<b>Docket Number:</b>	23-AFC-01
<b>Project Title:</b>	Morton Bay Geothermal Project (MBGP)
<b>TN #:</b>	256064
<b>Document Title:</b>	Morton Bay Geothermal Project Responses to Informal Data Request Set 1
<b>Description:</b>	N/A
<b>Filer:</b>	Lindsey Xayachack
<b>Organization:</b>	Jacobs
<b>Submitter Role:</b>	Applicant Consultant
<b>Submission Date:</b>	4/30/2024 12:19:46 PM
<b>Docketed Date:</b>	4/30/2024

# Responses to Informal Data Request Set 1

**Morton Bay Geothermal Project  
(23-AFC-01)**

Figure IDR1.b-1. Map of the Hudson Ranch Power 1 and Morton Bay production area with well course tracks with 500-meter merged buffers and area calculations based on Wilmarth (2015) methodology.

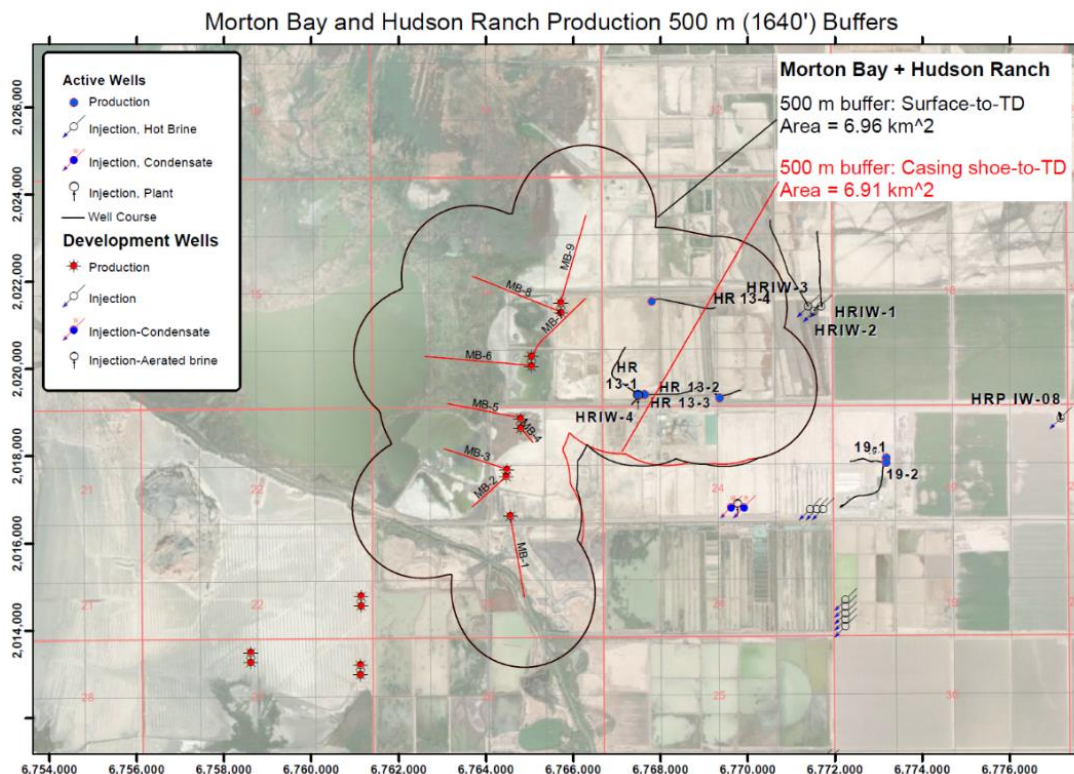
- b. *A specific response to Cyrq 's allegation that the power density of 217 MW per square mile far exceeds a sustainable level of 78 per square mile currently in production in the Salton Sea resource area.*

**Response:** The GRG Opinion asserts that the MBGP, as proposed, will result in a power density of 85 MW/km<sup>2</sup>, which the GRG Opinion claims is “nearly three times the known sustainable power density of the overall SSGF.”<sup>11</sup> These claims are incorrect.

Correct application of the power density methodology demonstrates that the MBGP results in a power density of 28.7 MW/km<sup>2</sup>, well within the alleged range of the sustainable development potential of the SSGF.

An accurate representation of the area that should be used to calculate power density is shown in Figure IDR1.b-1 below:

Utilizing the correct inputs per the Wilmarth (2015) methodology results in a conservative power density of 28.7 MW/km<sup>2</sup>. This conclusion is well within the range of power densities of 25-35 MW/km<sup>2</sup> for the

Figure IDR3.b-1. History matching results for Region 2

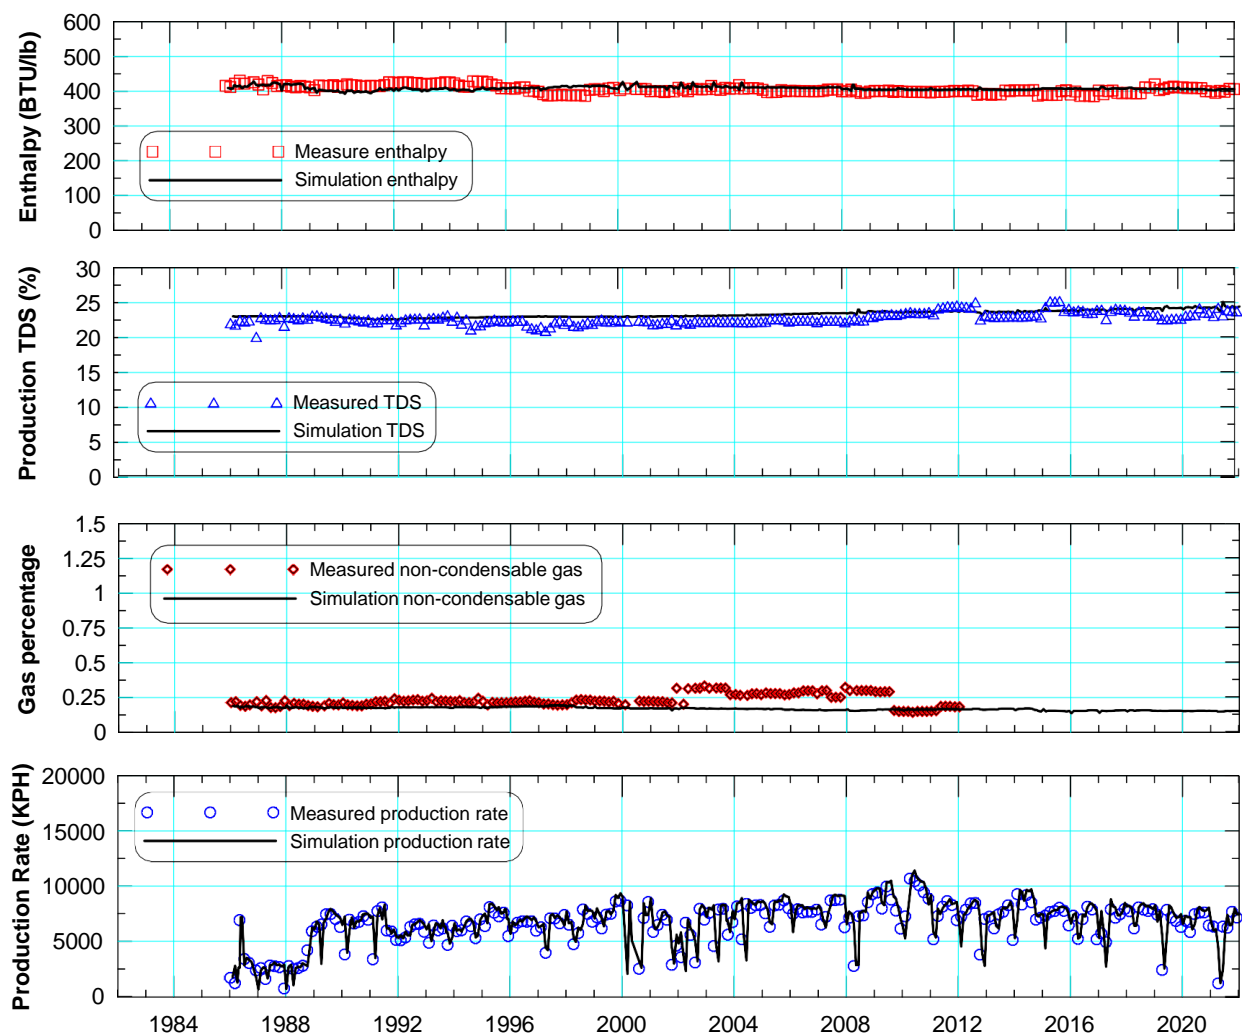
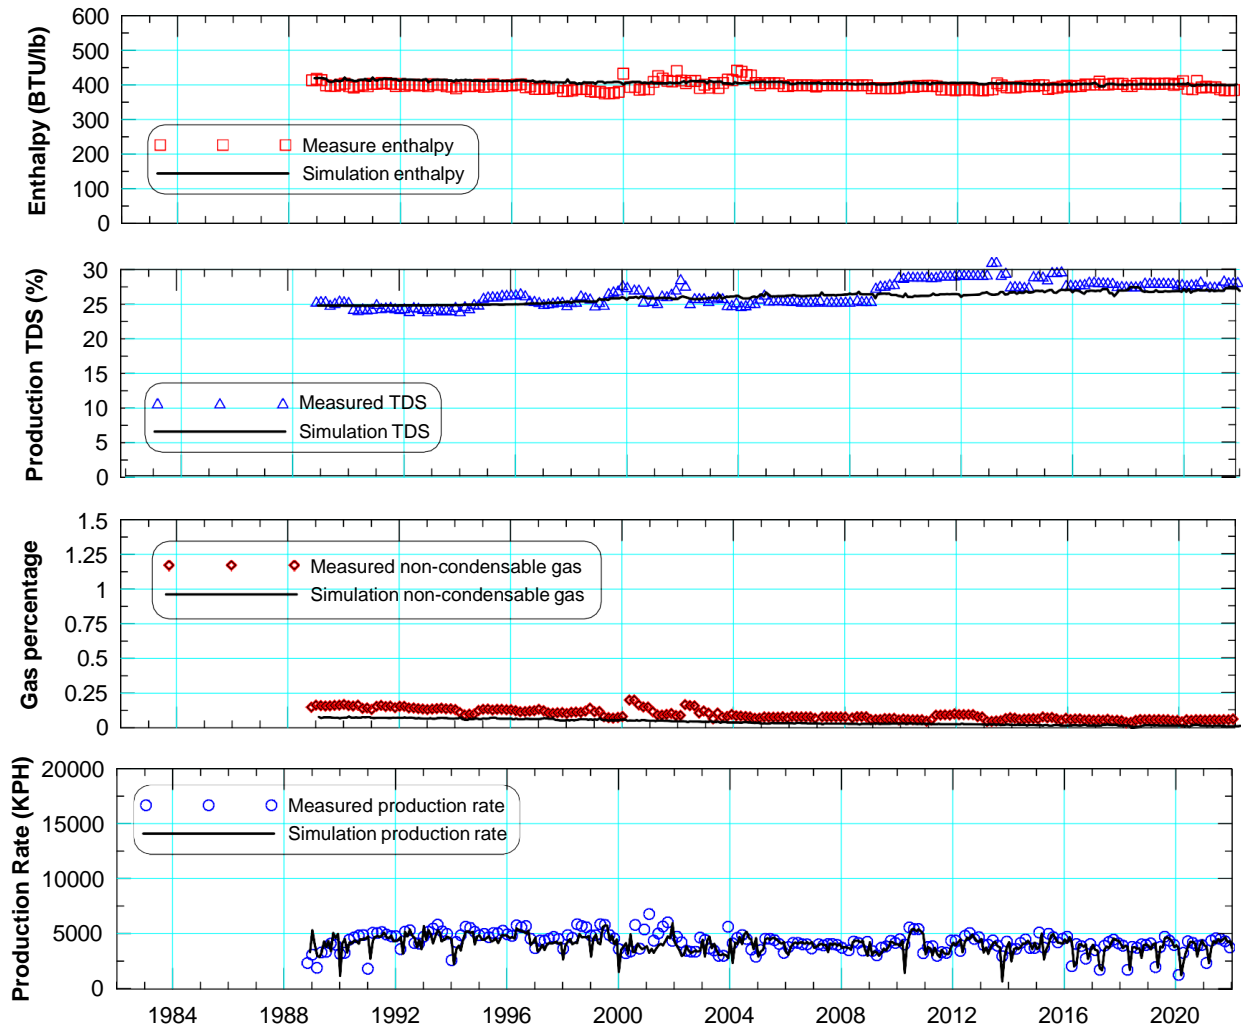
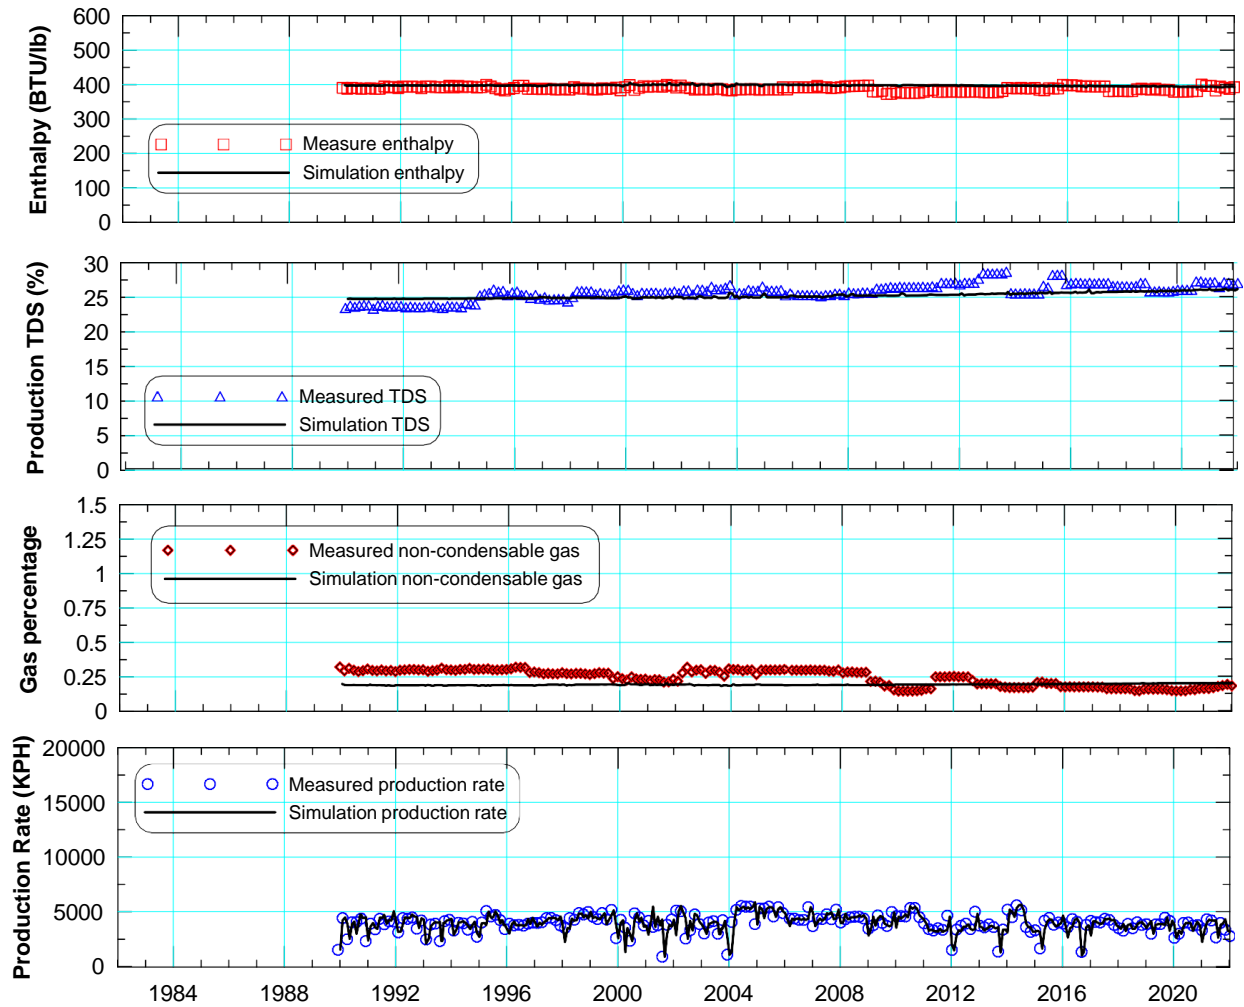
3. *GeothermEx prepared a model to evaluate the geothermal resource of the Salton Sea Geothermal Field (SSGF). The results of this model were presented in the Morton Bay Geothermal Project Resource Adequacy Report (Resource Adequacy Report) (TN250042).*
  - b. *History matching of reservoir pressure as seen in Figure 2.2 and enthalpy, total dissolved solids, and non-condensable gases as seen in Figure 2.3, include measured data points to demonstrate the validity of the model. Please include details, with geographic specificity, of measured data points, such as, but not limited to, identity, location, and depth.*

Figure 2.3 of the SSGR Numerical Resource Simulation shows the average values and concentrations for enthalpy, TDS, and NCG for Region 1 (Salton Sea Units 1 through 5). Figure IDR3.b-1 through Figure IDR3.b-3 below show the history matching results for the following existing facilities: Region 2, Elmore and Leathers. Figure 2.3 of the SSGR Numerical Resource along with Figure IDR3.b-1 through Figure IDR3.b-3 below show excellent history matching and model calibration.

Figure IDR3.c-1. Region 1 (Salton Sea Units 1-5) forecasts for enthalpy, production total dissolved solids, and non-condensable gases

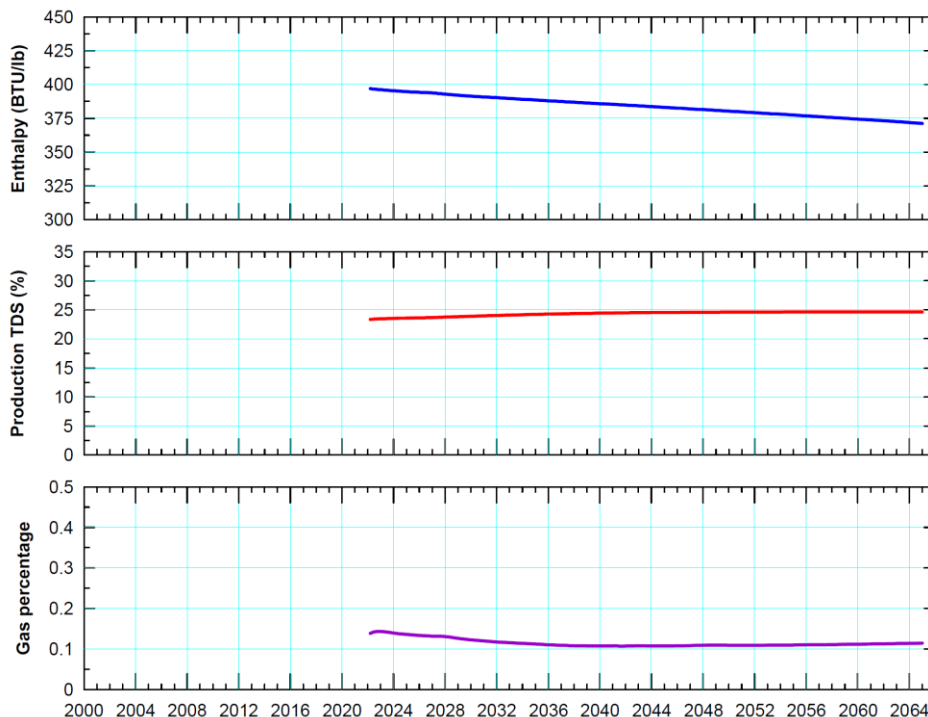
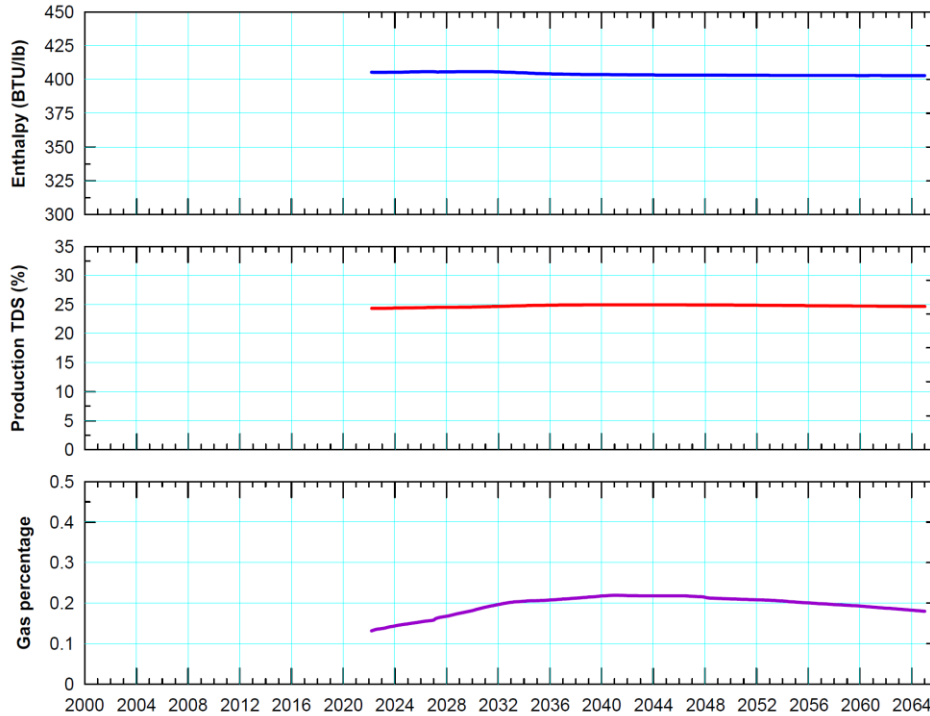
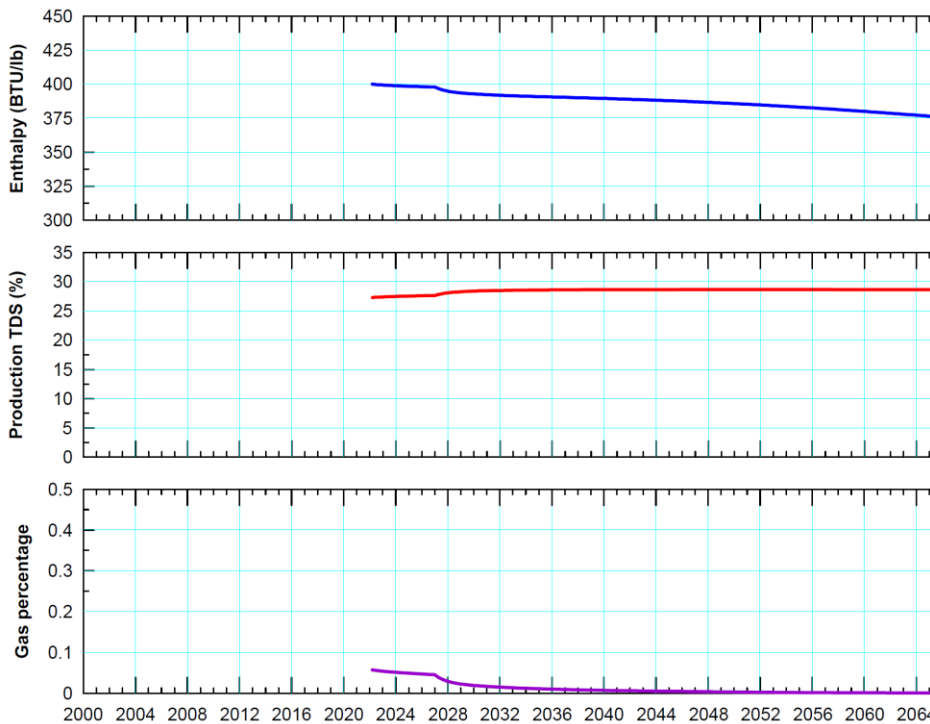
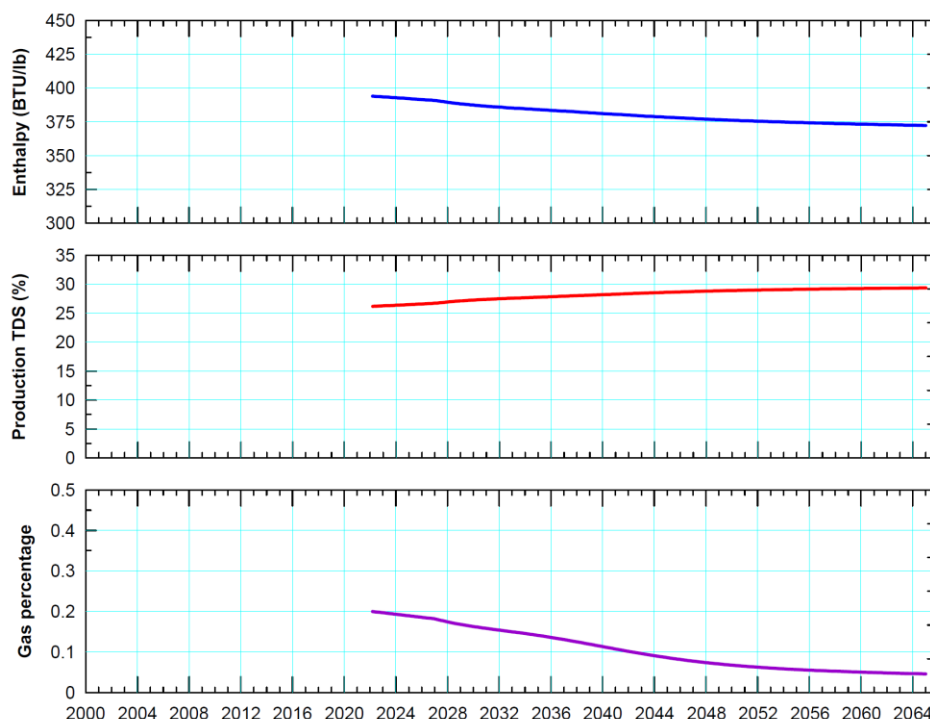
3. GeothermEx prepared a model to evaluate the geothermal resource of the Salton Sea Geothermal Field (SSGF). The results of this model were presented in the Morton Bay Geothermal Project Resource Adequacy Report (Resource Adequacy Report) (TN250042).
  - c. The aggregated forecast of enthalpy, TDS, and NCG for the Morton Bay Geothermal Project is shown in Figure 3.4 of the Resource Adequacy Report. Please provide similar forecasts, in disaggregated fashion, for all existing Berkshire Hathaway Energy Renewables projects listed in Table 3.1 of the Resource Adequacy Report. In addition, please identify where these results represented in the model are shown in Figures 1.1 and 2.1 of the Resource Adequacy Report.

Disaggregated forecasts of enthalpy, TDS and NCG for Region 1, Region 2, Elmore, and Leathers are displayed in Figure IDR3.c-1 through Figure IDR3.c-4 below.
